COUNCIL ASSESSMENT REPORT

Panel Reference	PPSSNH-575
DA Number	eDA0516/24
LGA	Ku-ring-gai
Proposed Development	Demolition works, tree removal, subdivision, lot consolidation and construction of a residential apartment development, including basement, landscaping and associated works.
Street Address	136 – 144 and 148 Fox Valley Road, Wahroonga
Applicant/Owner	Applicant: The Trustee for Capital Corporation Wahroonga 3 Unit Trust Owner: Australasian Conference Association Limited
Date of DA lodgement	3 December 2024
Total number of Submissions	Two
Number of Unique Objections	
Recommendation	Refusal
Regional Development Criteria Schedule 6 of the SEPP (Planning Systems) 2021	Estimated development cost of greater than \$30 million
List of all relevant s4.15(1)(a) matters	• Wahroonga Estate Concept Plan (MP07_0166) – MOD 9 (Concept Plan) • Environmental Planning and Assessment Regulation 2021 • Environmental Planning and Assessment (Savings, Transitional and Other Provisions) Regulation 2017 • State Environmental Planning Policy (Resilience and Hazards) 2021 • State Environmental Planning Policy (Biodiversity and Conservation) 2021 • State Environmental Planning Policy (Sustainable Buil

Figures 14 and 15: Proposed variations to the approved building envelopes

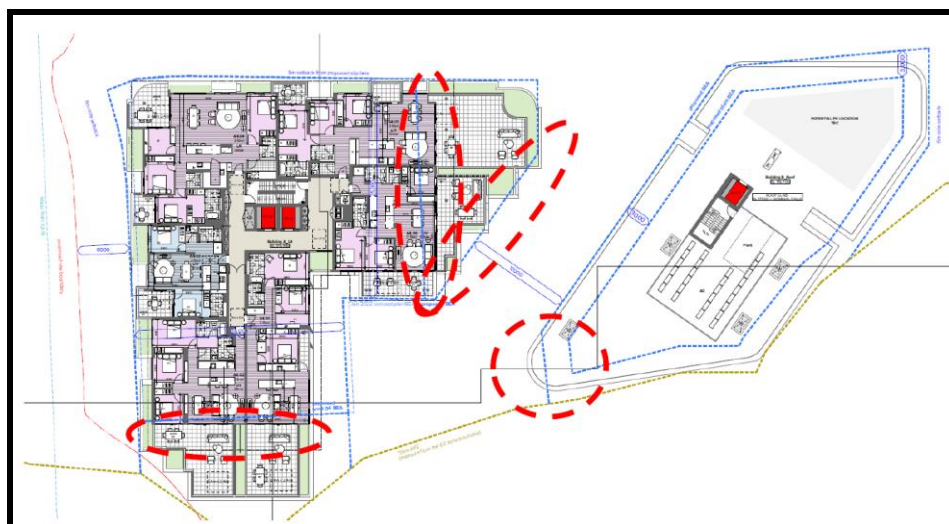
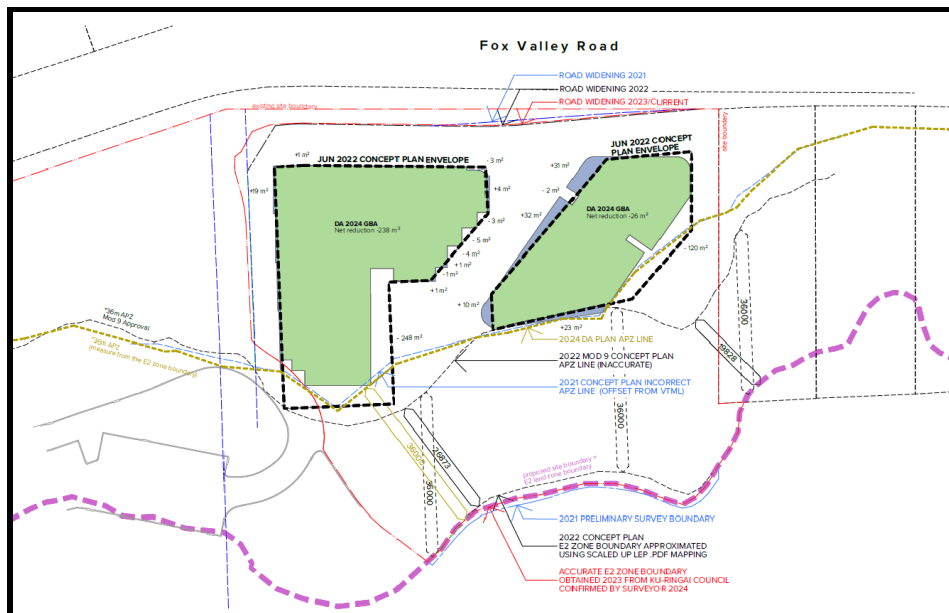
The proposal seeks a variation to the building envelope stipulated in Condition B1(1) (Figures 14 and 15).

The eastern façade of Building A is stepped and encroaches up to 1.7m into the

approved 12m internal building separation required under the Concept Approval.

A portion of the south-west facing balcony of Unit B3.04 extends a maximum of 2.4m beyond the approved building envelope.

A portion of the habitable area, balconies, roof and eaves on Level 4, Building A, encroaches beyond the approved building envelope to the south.

A portion of the habitable area, roof and eaves on Level 4, Building A, encroaches beyond the approved building envelope to the east.

The applicant has satisfactorily demonstrated that the variation to the approved building envelope will result in a superior built form and urban design outcome.

Figures 19 and 20: Site Plan and Lower Ground Floor Plan detailing proposed AZP from zone and site boundary (Source: Updated Bushfire Protection Assessment, Issue date 08.05.2025; Prepared by Australian Bushfire Protection Planners Pty Ltd)

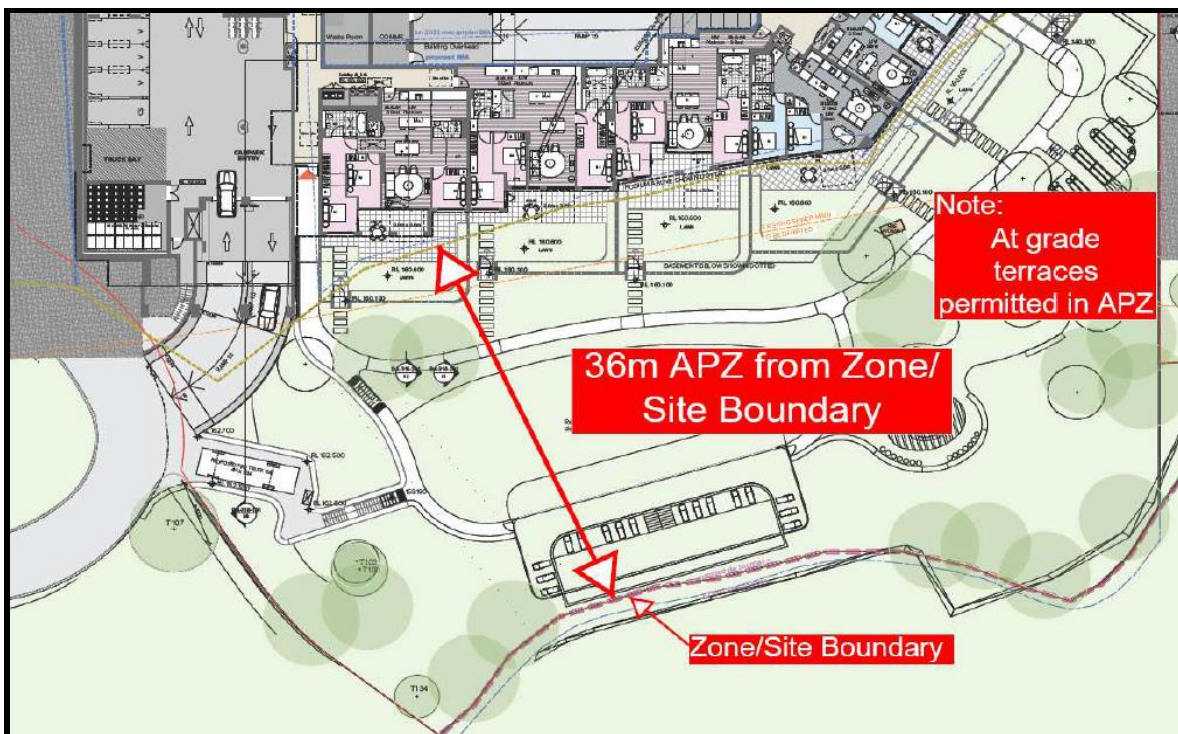
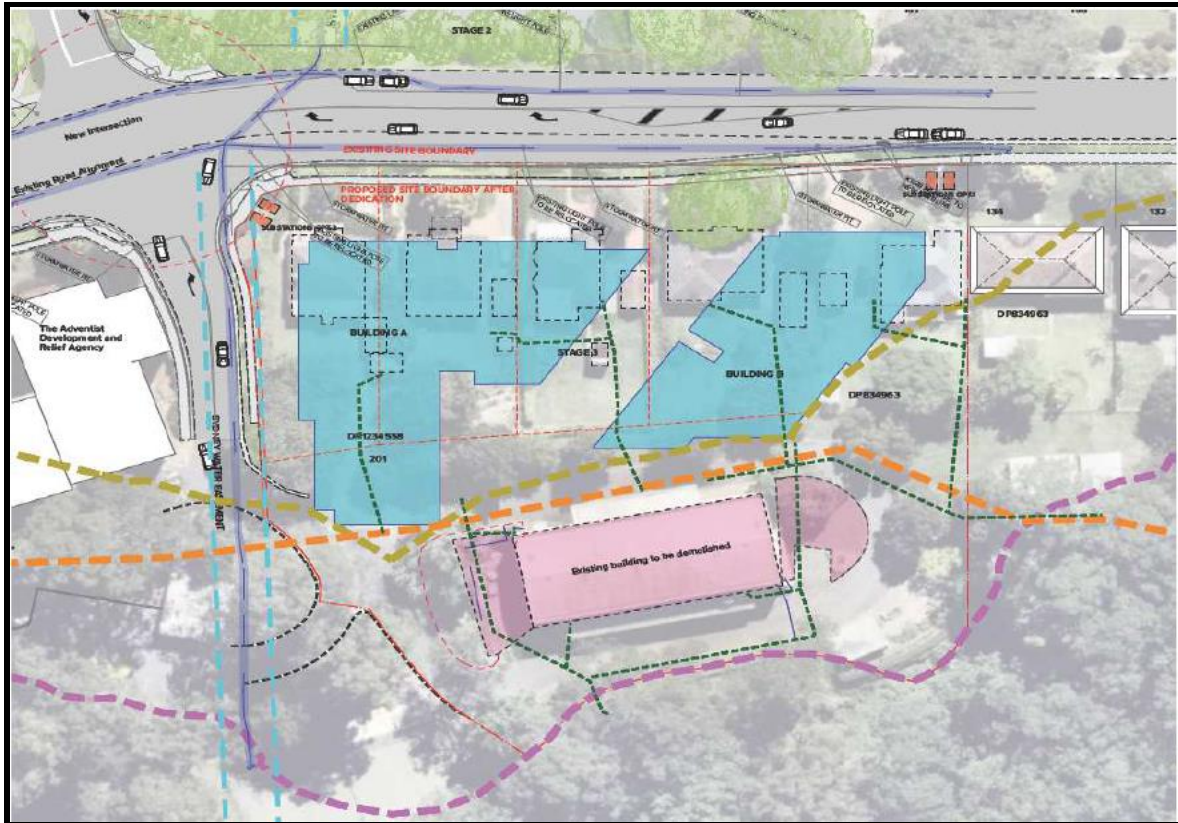
The proposal seeks to modify the approved APZ line, with the applicant justifying the variation on the basis that the APZ line in the approved Concept Plan was incorrectly plotted.

The approved plans supporting the Concept Plan (Mod 9) contained the following errors:

- The boundary of the E2 Environmental Conservation (now designated as the C2 Environmental Conservation Zone) was inaccurately plotted;
- As a result, the APZ line was also incorrectly shown as being 36 metres from the misaligned E2 zone boundary.

As detailed in **Figure 20**, the site boundary to the south is represented by a dashed red line, which aligns with the C2 Environmental Conservation zone, represented with a thick dashed purple line. The proposed amended APZ line is offset from the accurate site boundary and the C2 zone boundary by 36 metres.

Figure 21: proposed dispersion trench is located on the adjoining property, which is zoned C2 Environmental Conservation

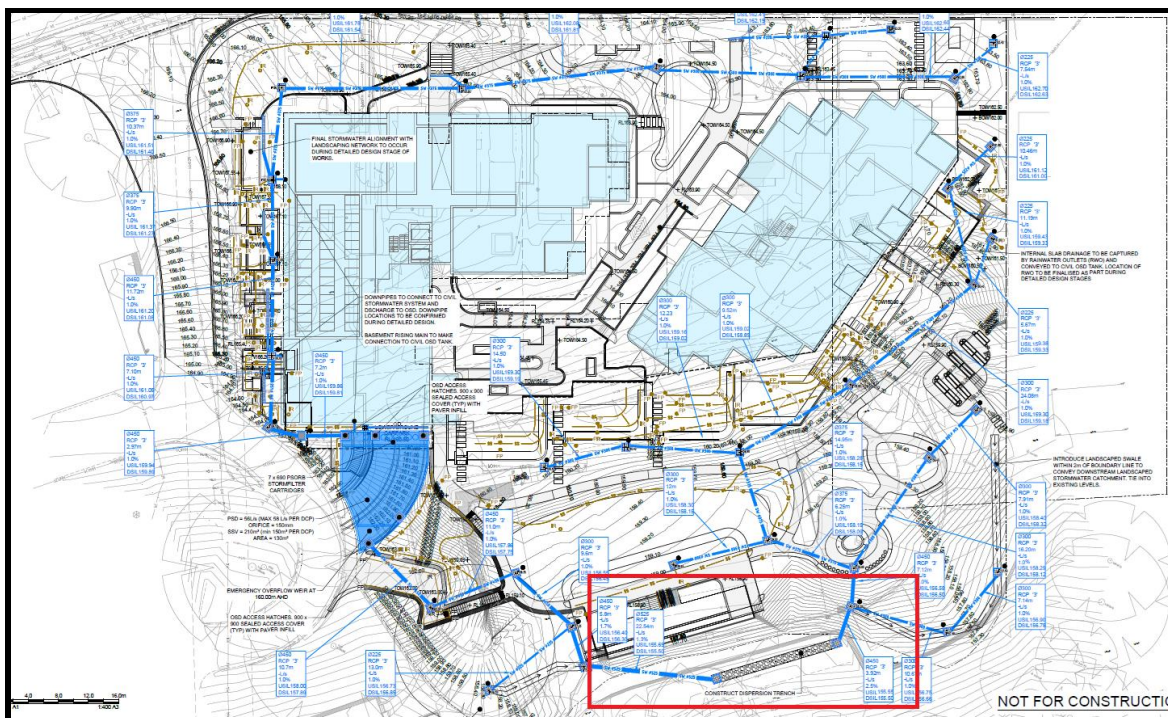
boundary, which is zoned C2 Environmental Conservation (**Figure 21**). The objectives of the C2 zone are:

Stormwater drainage works are a prohibited form of development within the C2 Environmental Conservation zone. Pursuant to section 4.3 'Development that is prohibited' of the Environmental Planning and Assessment Act 1979 and the zoning table for the C2 zone in KLEP 2015 consent for prohibited development cannot be granted.
